CITY OF LAS VEGAS INTER-OFFICE MEMORANDUM		DATE: March 31, 2020 
TO: Land Development Services Department of Public Works		FROM: Jennifer Shinn, P.E. Flood Control, Engr. Associate Department of Public Works
SUBJECT:	Drainage Study for:	
	Bremerton	
Cross Streets:	Tee Pee Lane and Grand Teton Drive	
File Number:	F:\PW_Flood\DSMEMOS\DS5239B.docx	
Parcel Number:	126-18-501-014	
Zoning Action:	TMP-77764	
FEMA Flood Zone	YES	NO X
Proposed Storm Drain	YES X	NO
COPIES TO:		
		Westwood Professional Services
		USA/KB Home Nevada Acquisition, LLC
		Bart Anderson, P.E., DevCo

TECHNICAL DRAINAGE STUDY ADDENDUM

Bremerton

This letter is submitted in response to the comments contained in the February 20, 2020 review memorandum, regarding the above referenced project. A copy of the City of Las Vegas (CLV) comment letter has been provided in Appendix A.

SD-1
SHEET 10 OF 32

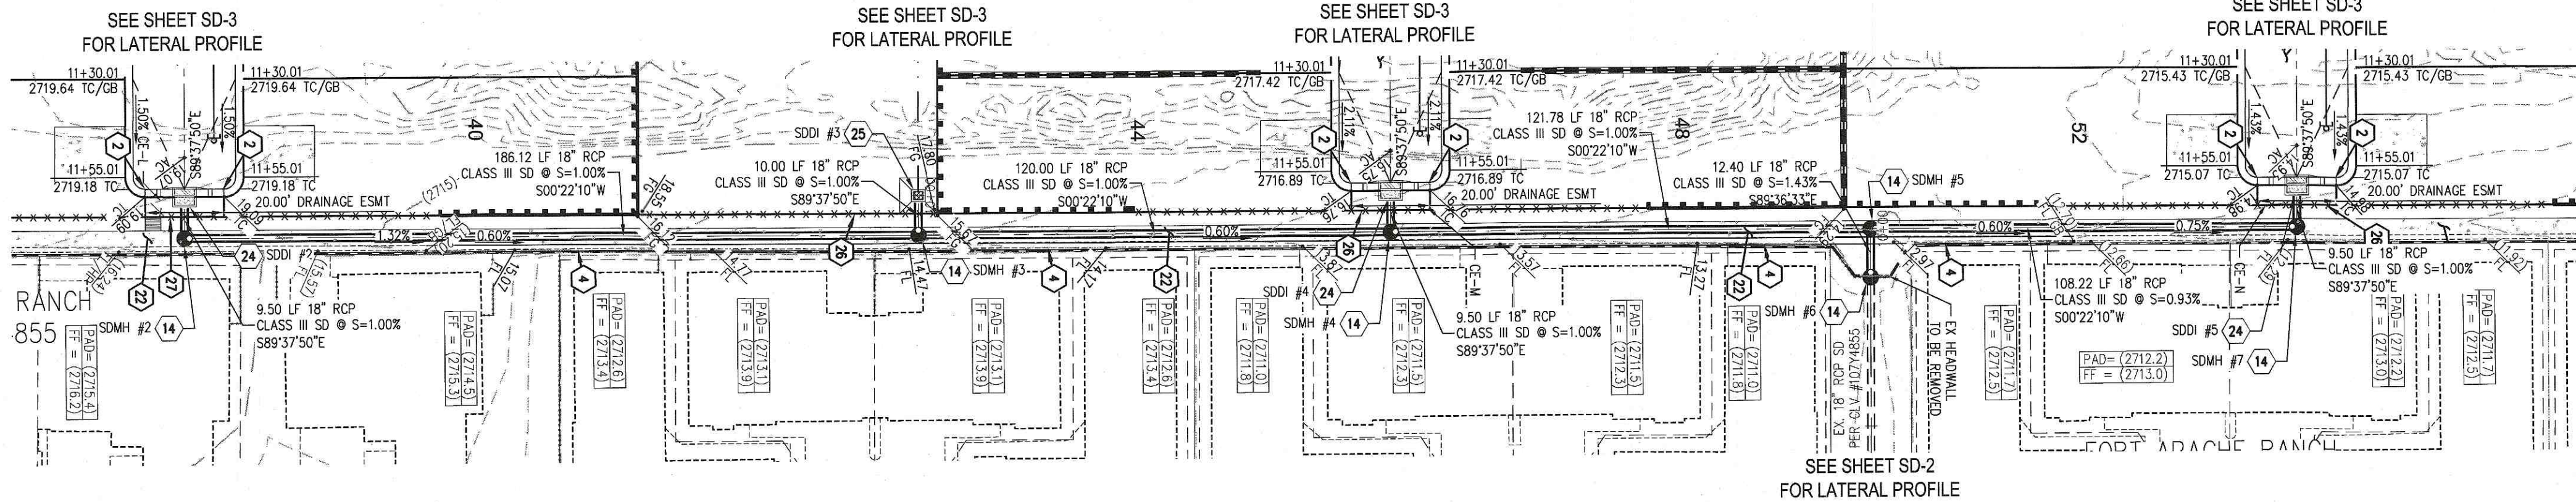
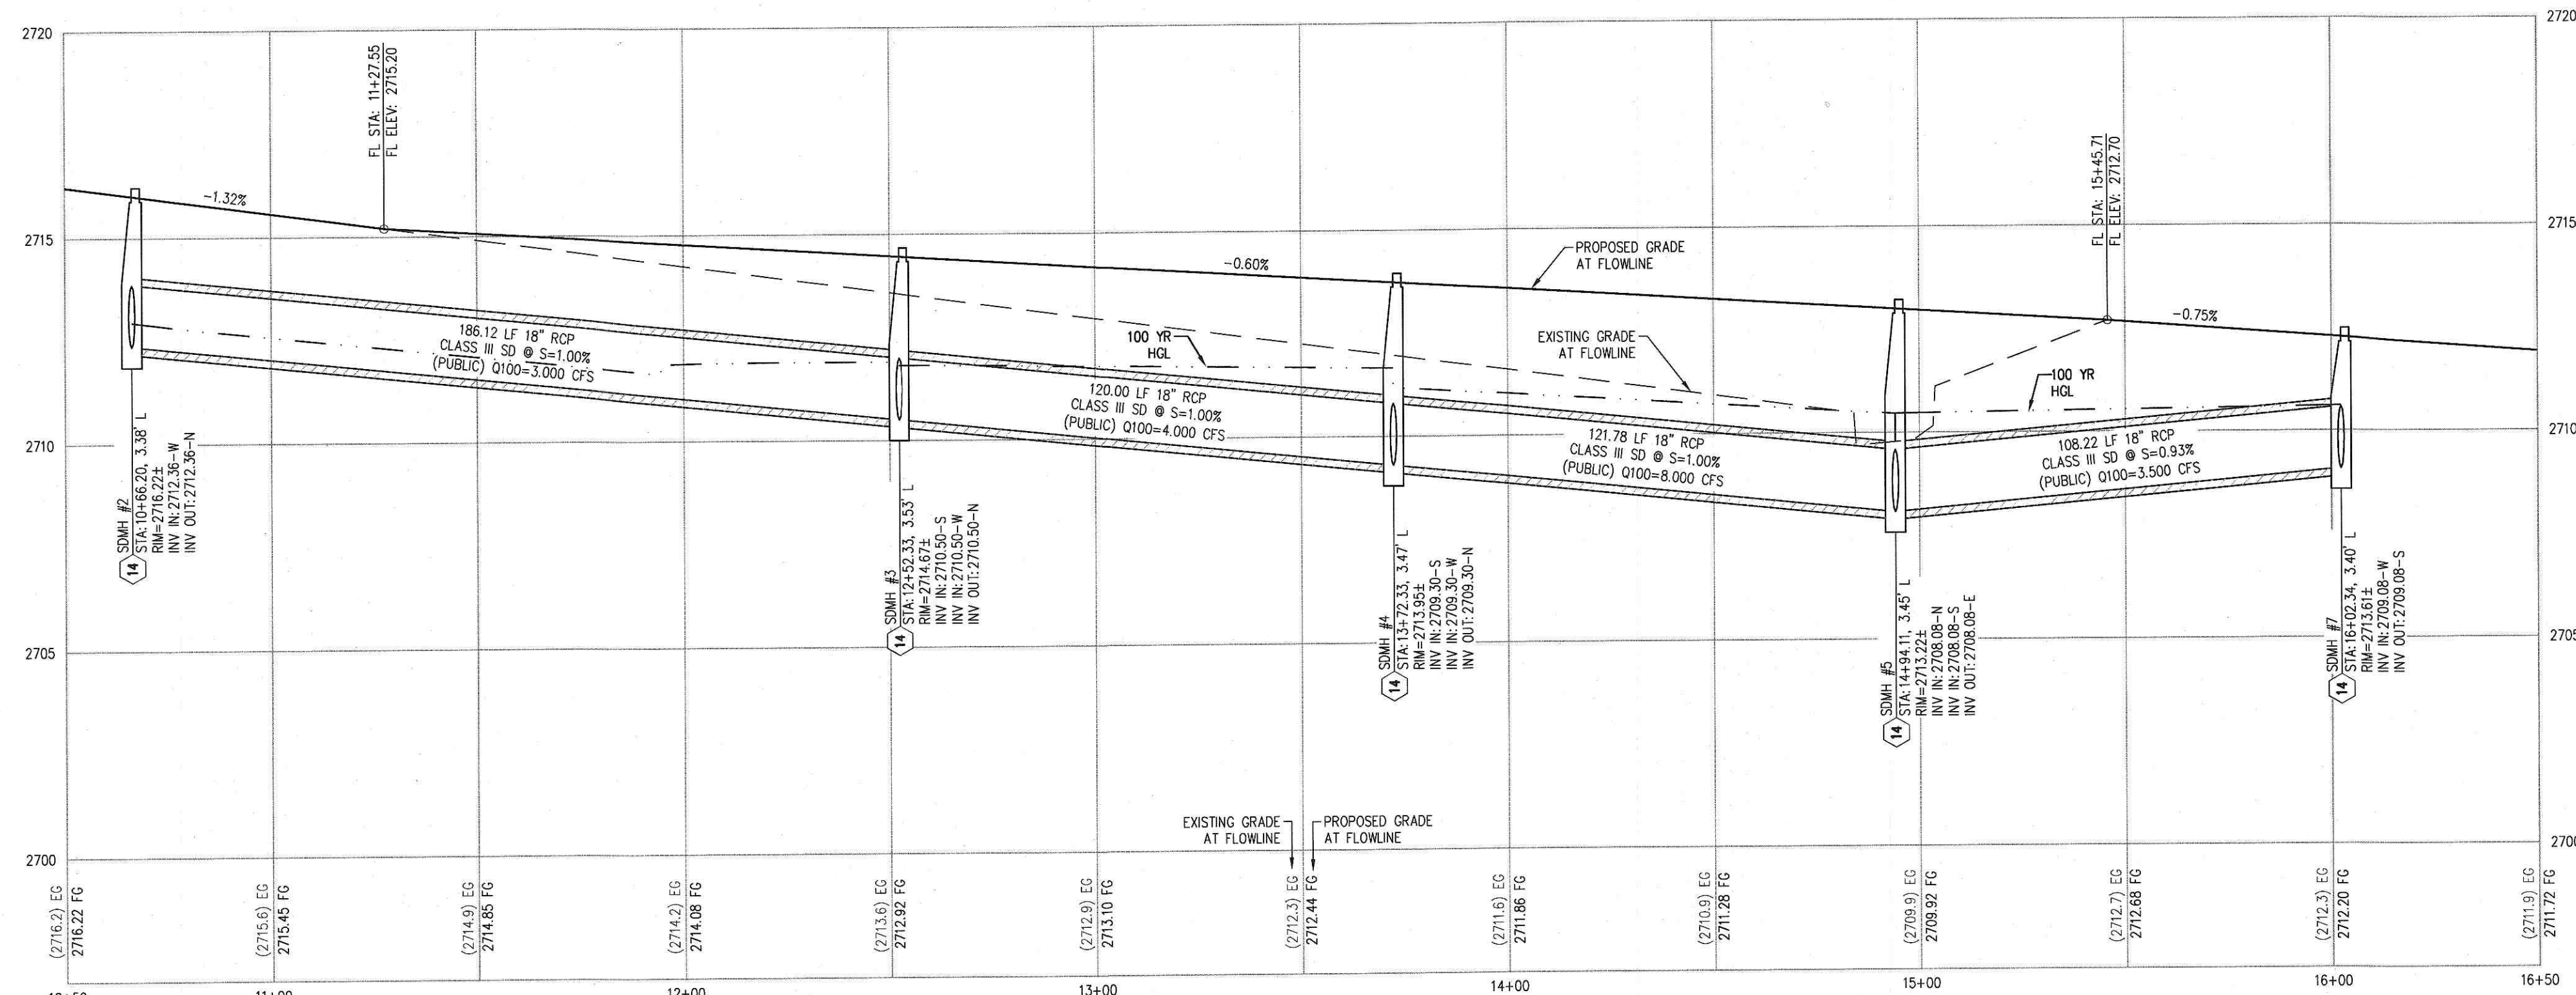
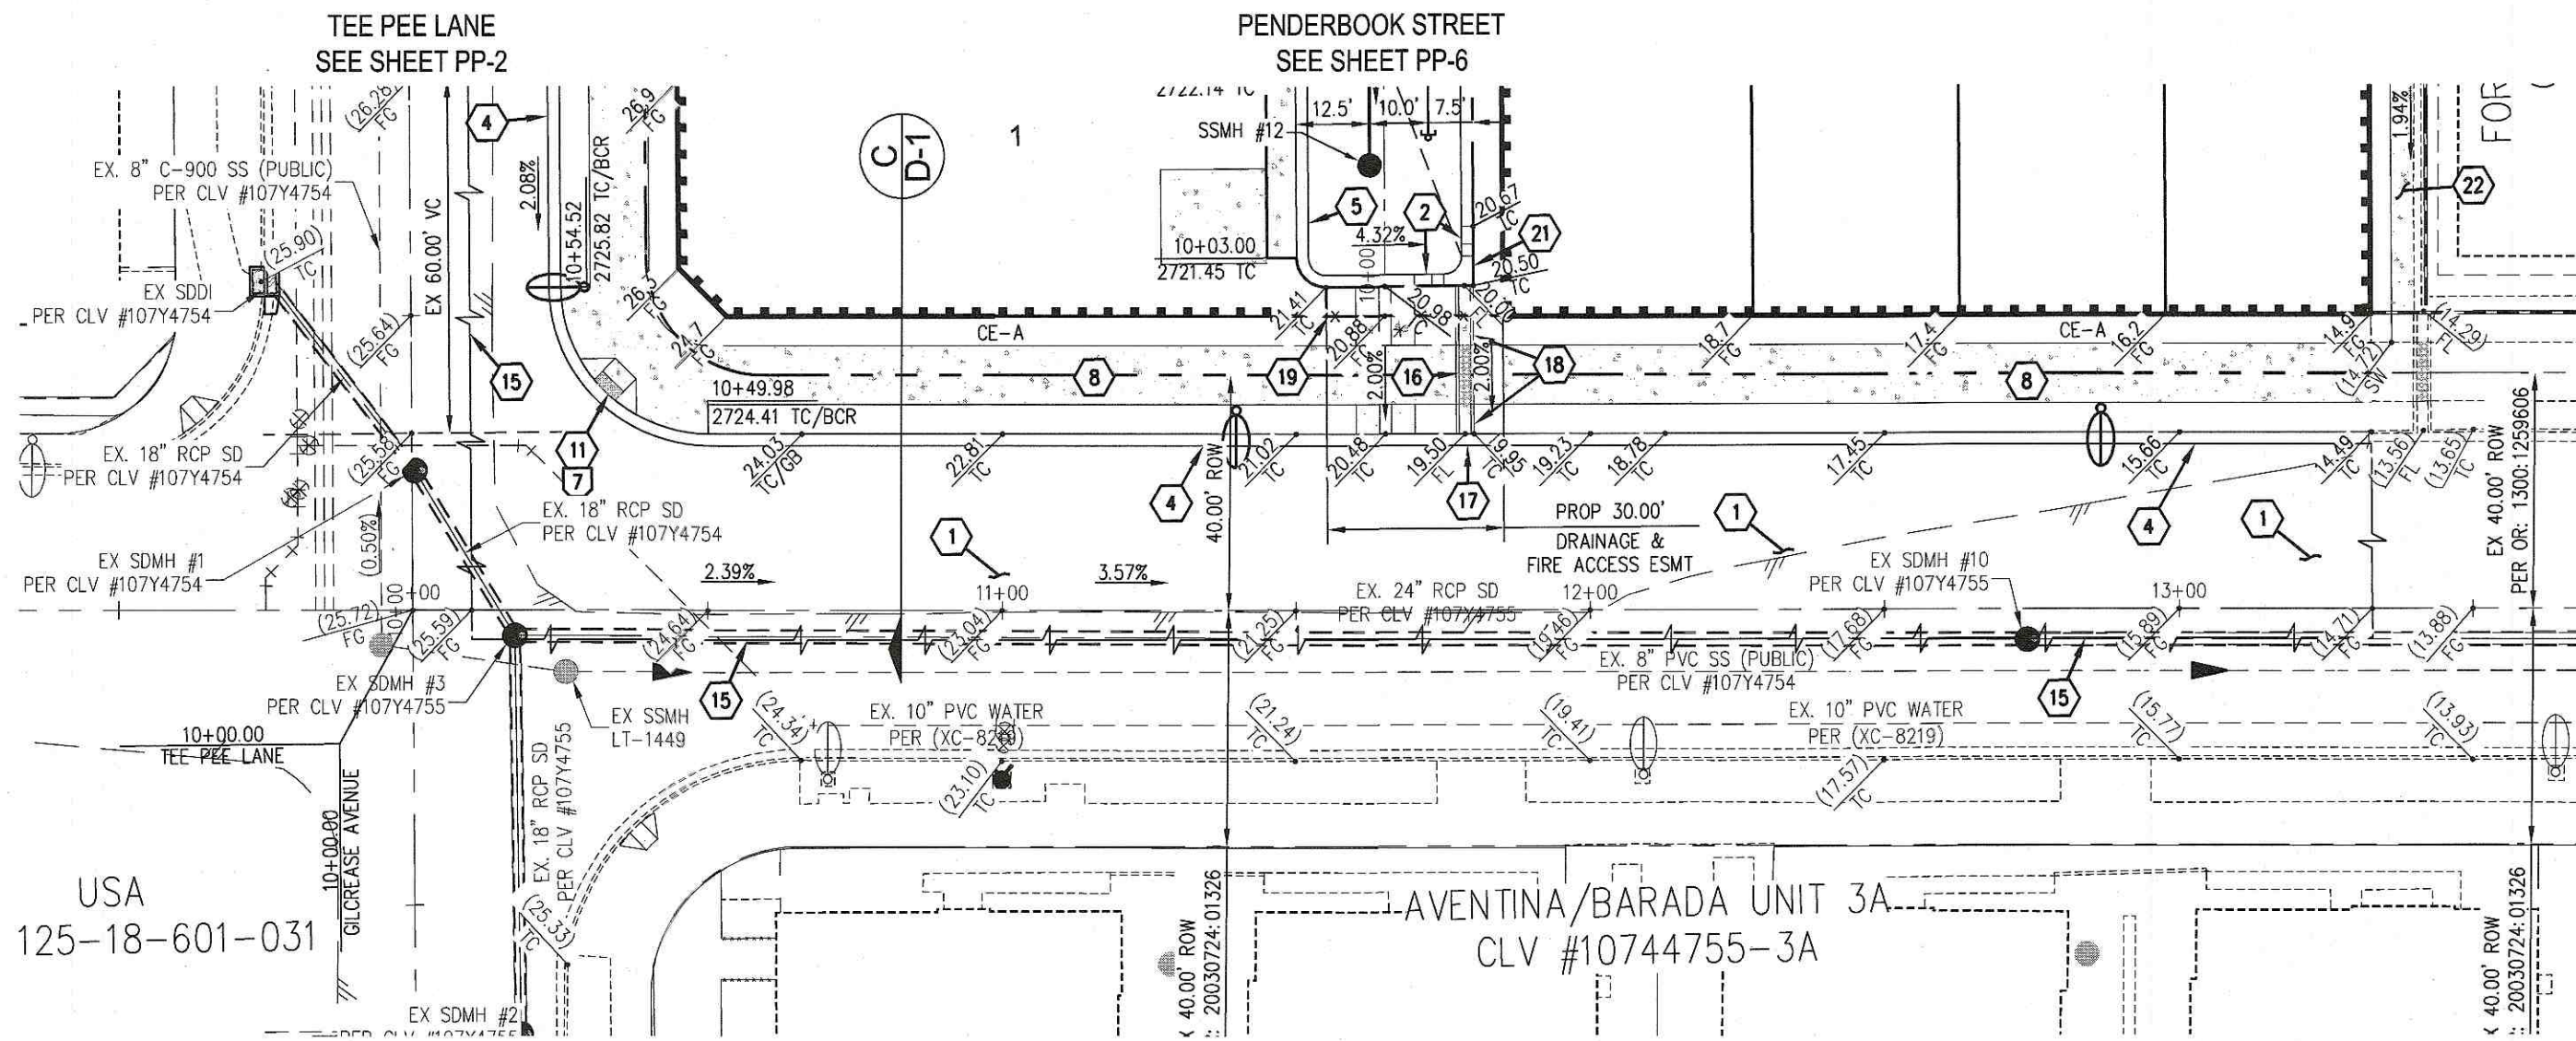
1. Add a note to the Grading Plans: " All private streets are public drainage easements and public sewer easements to be privately maintained by the HOA."
2. Label onsite storm drain as private on Plan and Profiles.
3. Label length and depth of SDDI #5 on Profile View on Sheet SD-3.

- 17. Comment:** *SD-1 plan view shows construction notes 22, 26, 27 however, the construction note list only shows numbers 1-19.*

17. SD-1 plan view shows construction notes 22, 26, 27 however, the construction note list only shows numbers 1-19.
18. Label inlets on the grading plans or provide a better way to identify the storm drain profiles. The inlets have a name on the profile but not in plan therefore it is difficult to decipher which inlet is which on the profiles.

Response: Acknowledged. Sheet SD-1 has been revised to include all the construction notes.
